Access Compliance Report

Public Rights-of-Way

Intersection ID: 14754	Main Street: SOUTH_BV	Cross Street: IVERSON_WY	Location: S
ADA ID: 1F640AFDE1A9	Ramp Type: Perp	Initial Pass/Fail: Fail	Overall Compliance: No
			Severity Score: 8.75

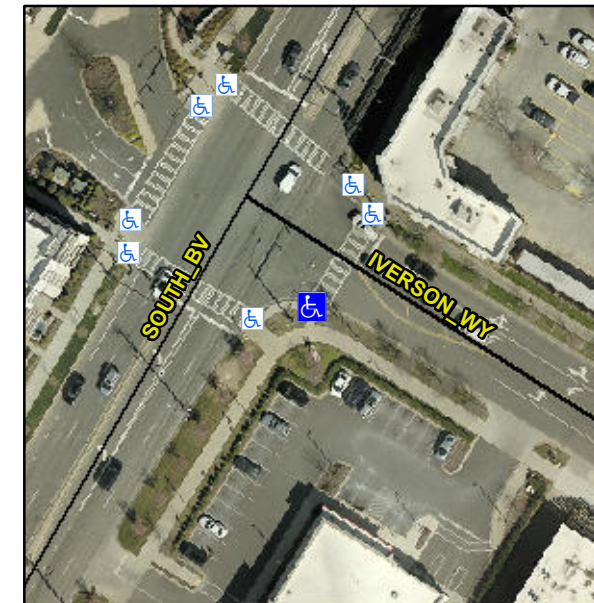
R304.5.1

Compliance	Description	Data	Compliance	Description	Data
N/A	Ramp Length (in)	48.0	Yes	Ramp Slope (%)	6.1
No	Ramp Width (in)	47.0	Yes	Ramp XSlope (%)	1.7
N/A	Flare Type LT	N/A	N/A	Flare Type RT	N/A
N/A	Flare Slope LT (%)	N/A	N/A	Flare Slope RT (%)	N/A
N/A	Flare Traversable LT?	N/A	N/A	Flare Traversable RT?	N/A
N/A	Landing Length (in)	N/A	N/A	DWS Provided?	N/A
N/A	Landing Width (in)	N/A	N/A	DWS Contrast?	N/A
N/A	Landing Slope (%)	N/A	N/A	DWS Length (in)	N/A
N/A	Landing X Slope (%)	N/A	N/A	DWS Full Width?	N/A
N/A	Landing Curb? (Y/N)	N/A	N/A	DWS Offset (in)	N/A
N/A	Shared Landing?	N/A			
N/A	Gutter Ponding?	N/A	N/A	Gutter Slope (%)	N/A
N/A	Gutter Lip Ht (in)	N/A	N/A	Gutter X Slope (%)	N/A
N/A	Painted X Walk1?	Yes	N/A	Painted X Walk2?	N/A
	X Walk 1 Direction	To NE		X Walk 2 Direction	N/A
N/A	X Walk 1 Width (in)	113.0	N/A	X Walk 2 Width (in)	N/A
	X Walk 1 Slope (%)	5.3		X Walk 2 Slope (%)	N/A
	X Walk 1 X Slope (%)	2.9		X Walk 2 X Slope (%)	N/A

Remove & Replace Entire Ramp.
